Traffic Engineering RFI Response Letter

5 June 2025
Our Ref: 23BRT0507
Council Ref: COM/2024/317

Re: 202 Baileys Mountain Road, Upper Coomera – Request for Information Response

Figure 2-2: Turn Treatment Warrant Assessment – Right-turn into Subject Site

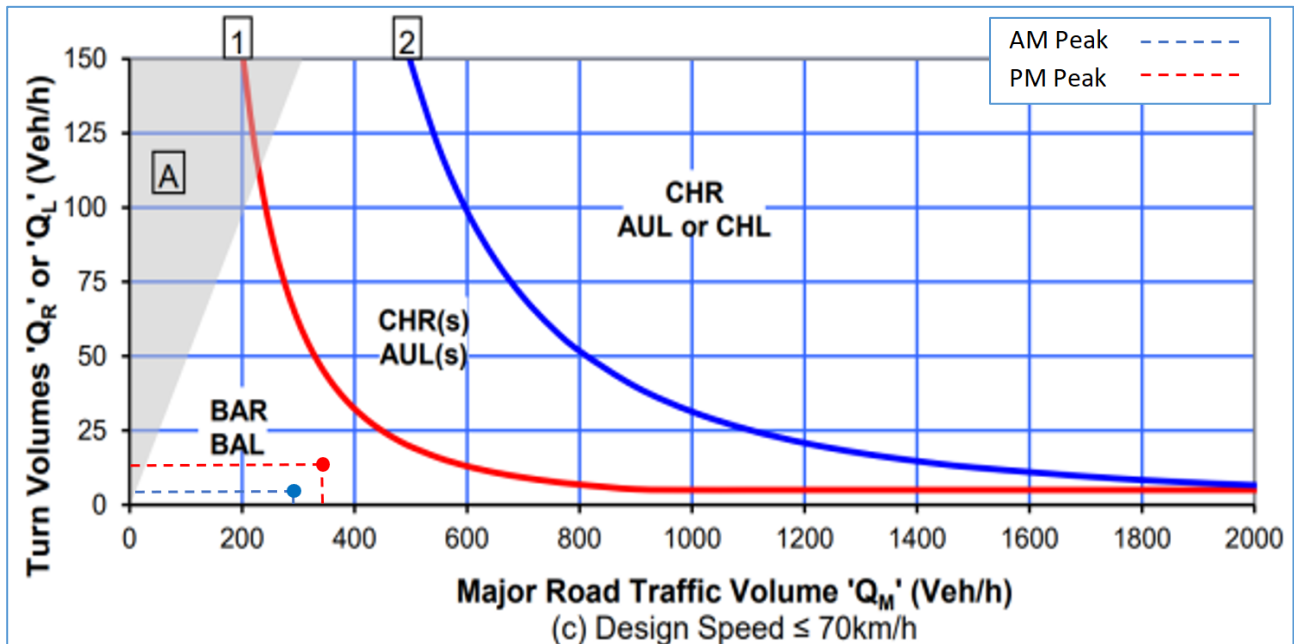
- (a) *Demonstrate the required form of intersection for the proposed new public road with Baileys Mountain Road. The physical configuration of the intersection shall be suitable, and provide sufficient capacity, to accommodate the 'ultimate' traffic demands intended to use the public road, noting that the Town Planning Report states that 'The new local access road will also provide access for neighbouring properties in the sub-precinct, minimising intersections with Baileys Mountain Road'. The proposed intersection design shall be supported by an Austroads turning warrants assessment (if a priority-controlled intersection is appropriate), and also by SIDRA Intersection assessment based on 'ultimate' traffic volumes. Appropriate growth rates shall also be applied to background traffic volumes on Baileys Mountain Road (as per the table provided, below). Of note, TTM Consulting's Transport Engineering Report does not sufficiently address*

intersection design as it does not quantify 'ultimate' traffic demands or demonstrate the results of a turning warrants assessment (additionally, the proposal for the provision of 'basic' left and right turning treatments, as identified in Section 5.1 of the report, has not been substantiated). To be clear, the 'ultimate' intersection design must be identified at this stage so that appropriate infrastructure can be provided. A revised, fully dimensioned functional layout drawing showing the required intersection design, signed by an RPEQ Traffic Engineer, shall be submitted.

As shown above, the turn warrants assessment indicate that the following:

- A BAR treatment identified for right-turn from the Baileys Mountain Road north approach.
- A BAL treatment identified for the left-turn from the Baileys Mountain Road south approach.

Colliers propose to retain the arrangement of the adjacent site, BAR and AUL, for the current development proposal. The access will be used by both the current development and the adjoining development (ROL/2024/116). This is considered sufficient to meet 'ultimate' traffic demands. Comparing the 'ultimate' intersection design against the proposed road upgrade works to Baileys Mountain Road indicates generally appropriate tie-in into the future works, refer to Figure 2-4.

Figure 2-8: Indicative Road Network Layout Plan (Rev K – 06 May 2025)

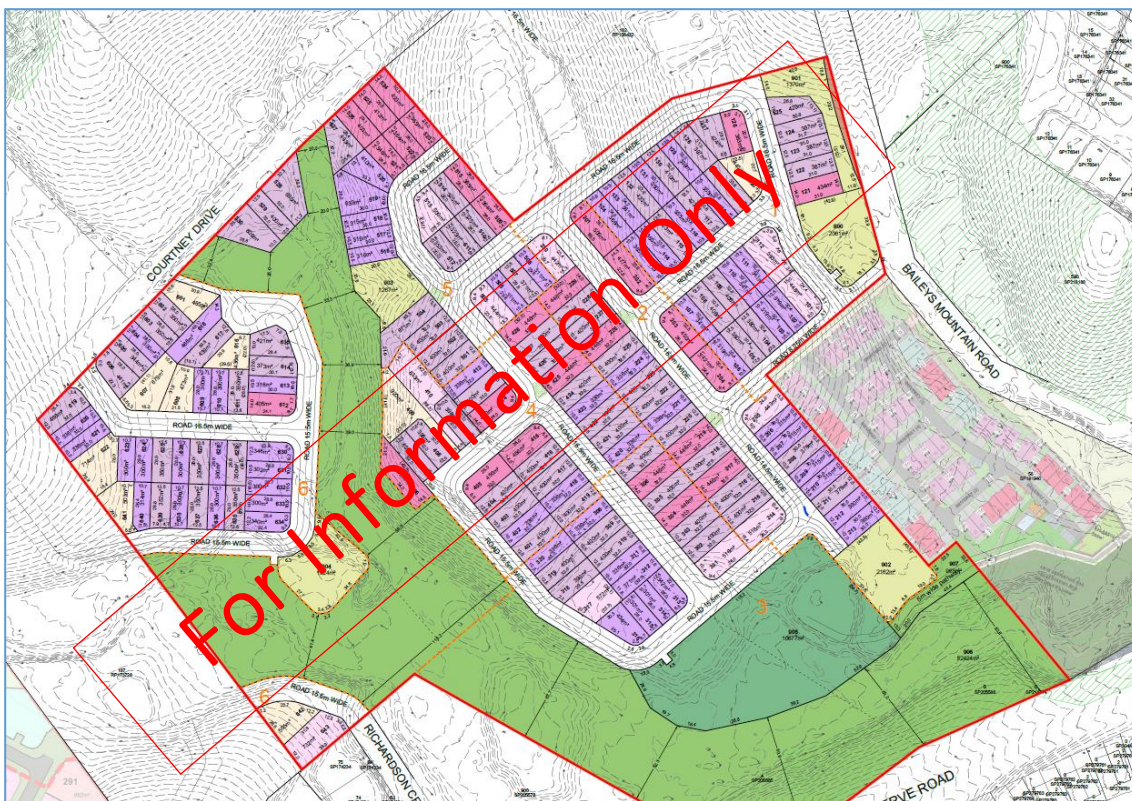
- (a) Provide an indicative road network layout plan which includes indicative future development for the subject site and surrounding lots 184RP173727, 185RP173727 and 56RP162858.

The plan indicates connection of the current proposal to the lots referenced by Council.

PROJECT NUMBER 23BRT0507	ORIGINAL SIZE A3
DRAWING NUMBER 23BRT0507-04	REVISION C
DATE 27 May 2025	SHEET 1 OF 1

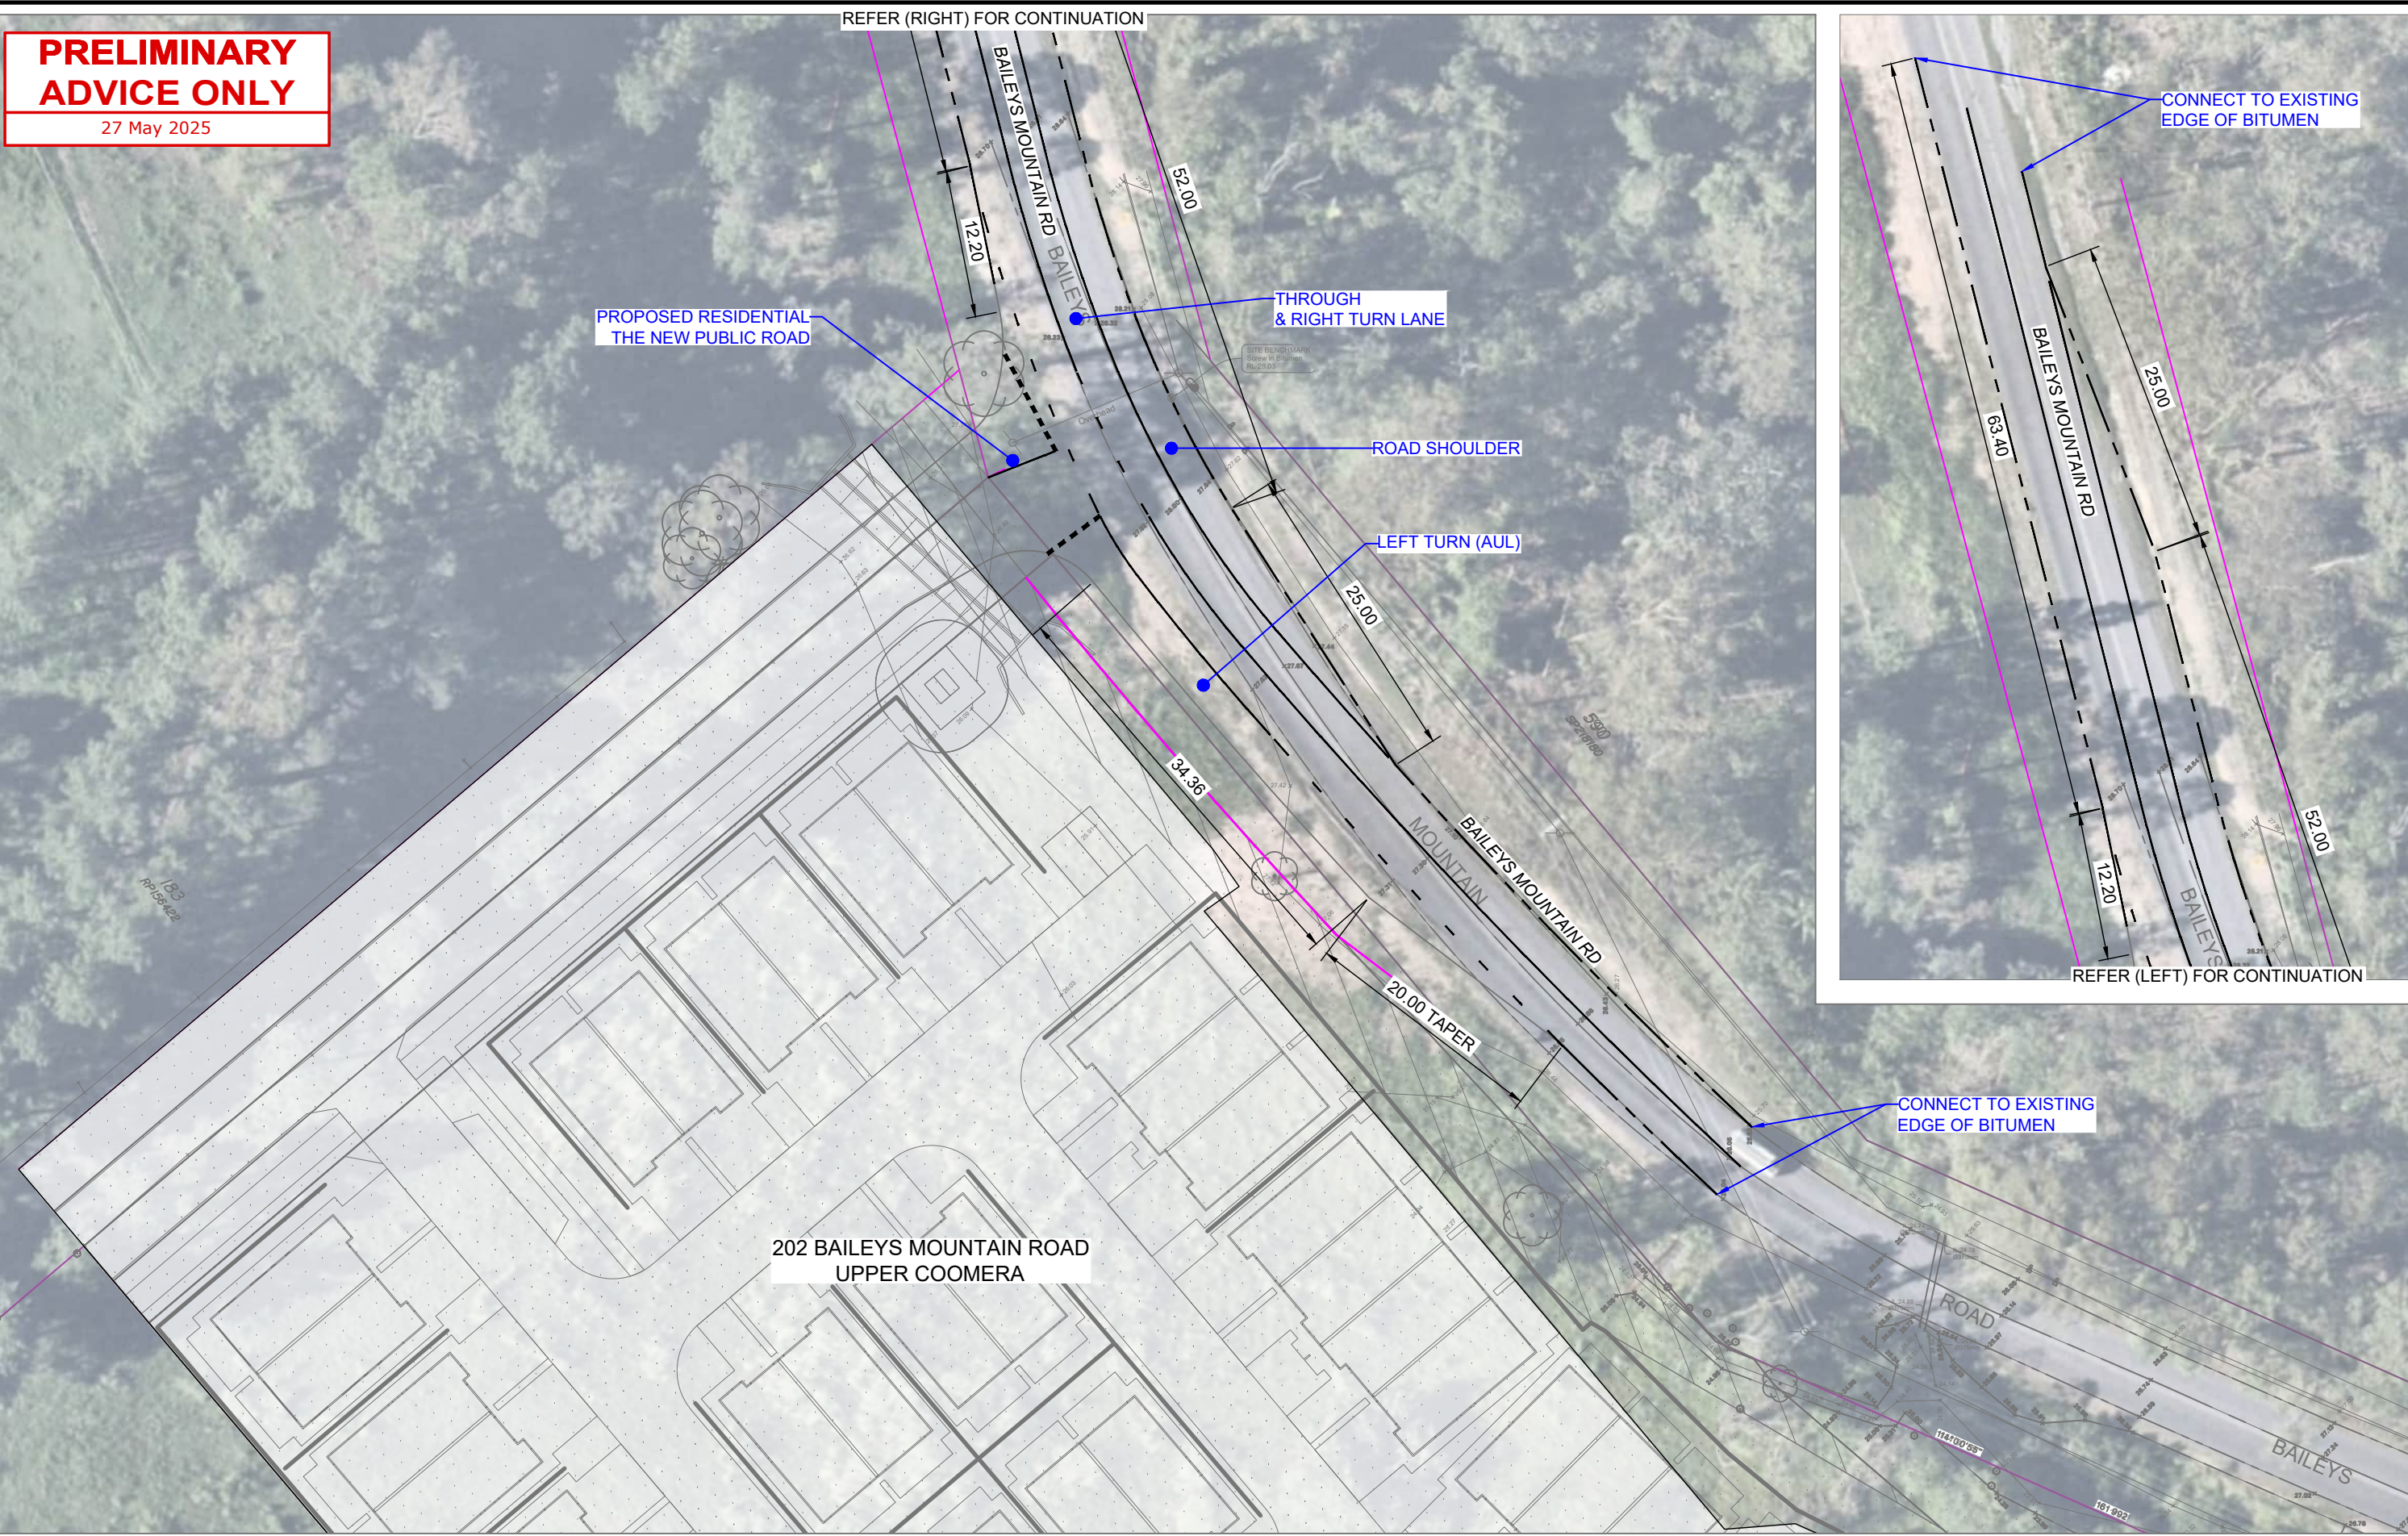
(b) Further to point (a), the functional layout drawing must demonstrate that the proposed intersection design achieves full compliance with all relevant design standards (including Council's standards and Austroads guidelines) - this includes (but is not limited to) the alignment of the new public road with respect to Baileys Mountain Road (the two roads shall meet at 90 degrees), lane widths, verge widths, horizontal alignment, etc. In addition, it must be demonstrated that the proposed intersection design ties into Council's road planning for Baileys Mountain Road (Council will provide drawings showing the relevant road planning, in this regard). The drawing shall also show the required corner truncations at the new intersection, and kerb and channel for the extent of works (between the tangent point and taper of any turn lanes). In addition, any errors shown on the functional layout drawing shall be corrected (including, but not limited to – consistent identification of turning treatments, including within the title block, removal of reference to the new public road as a 'driveway', etc).

Please refer to the functional layout (see **Attachment B – 23BRT0507-04**), which has been designed to Austroads 'Guide to Road Design Part 4A: Unsignalised and Signalised Intersection' requirements for the urban auxiliary left (short lane) and urban basic right turn treatments.

PROJECT NUMBER	23BRT0507	ORIGINAL SIZE	A3
DRAWING NUMBER	23BRT0507-05	REVISION	C
DATE	27 May 2025	SHEET	1 OF 1

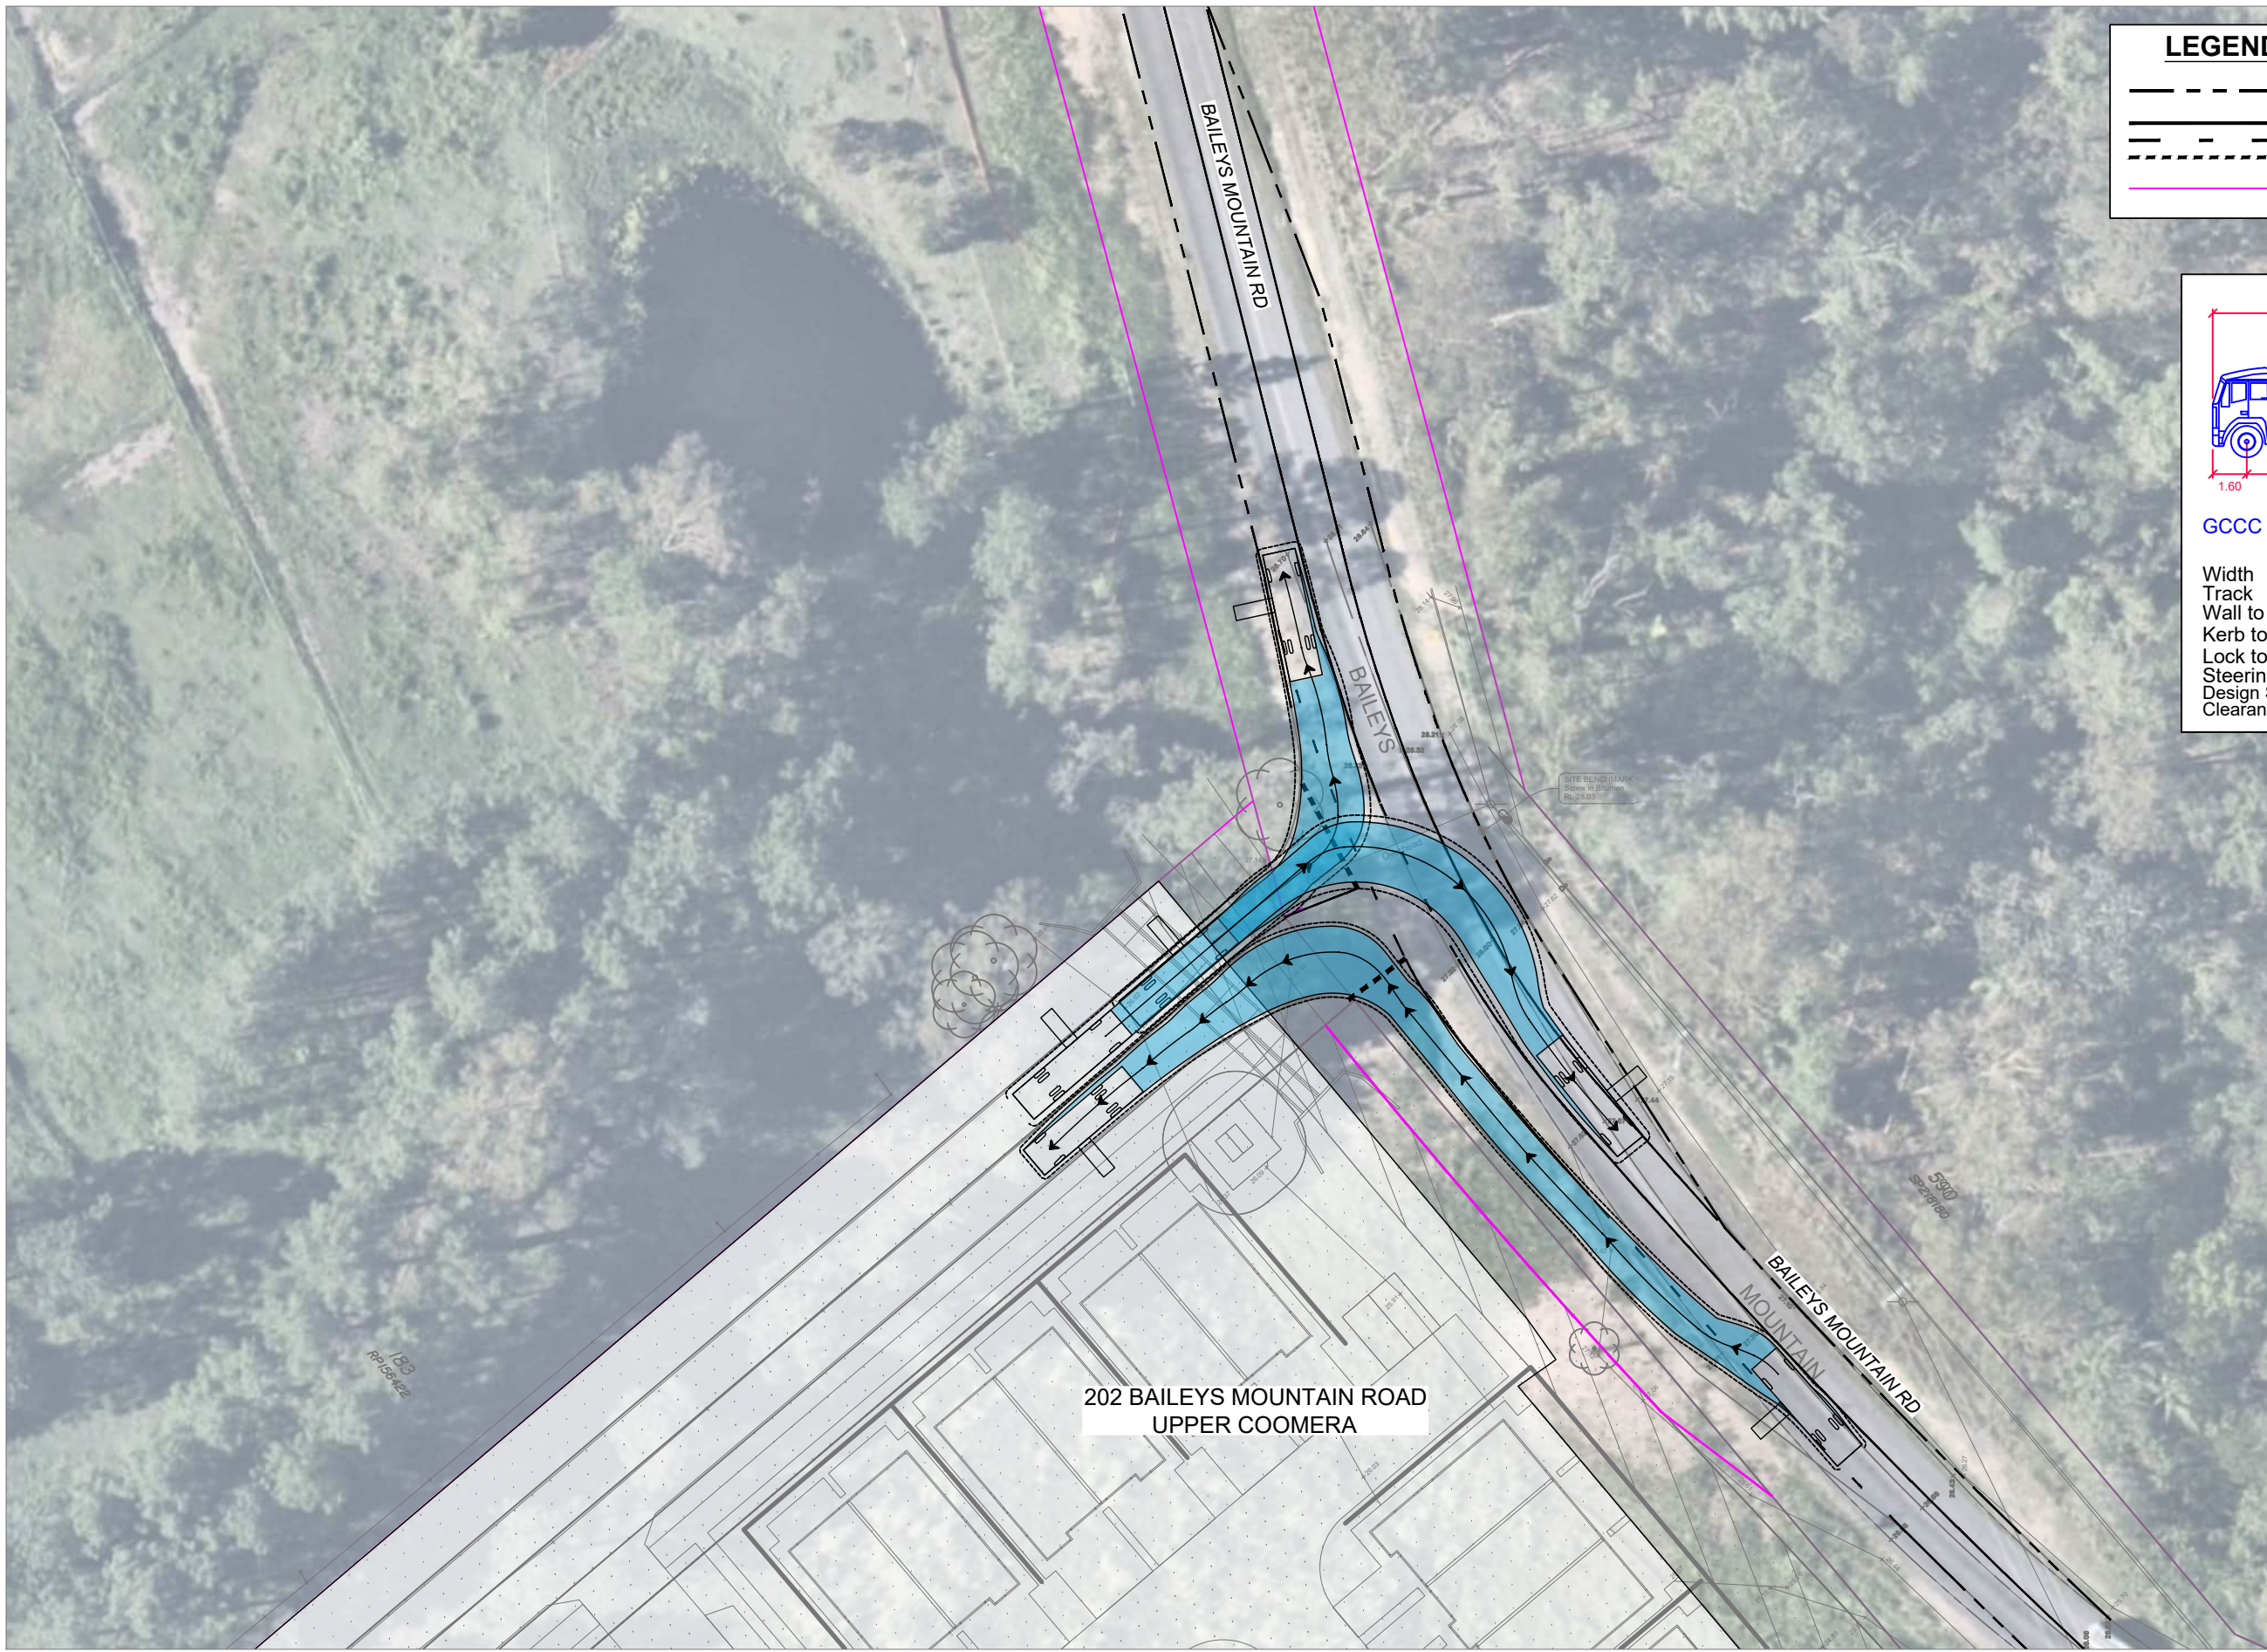
(c) Submit an updated swept path (using the 'design service vehicle') based on the amended intersection design.

Swept paths have been conducted with the updated intersection layout (see **Attachment B – 23BRT0507-05**), indicating that the design service vehicle of a GCCC 9.8m side loader RCV is able to ingress / egress the proposed site access road to / from at Baileys Mountain Road adequately.
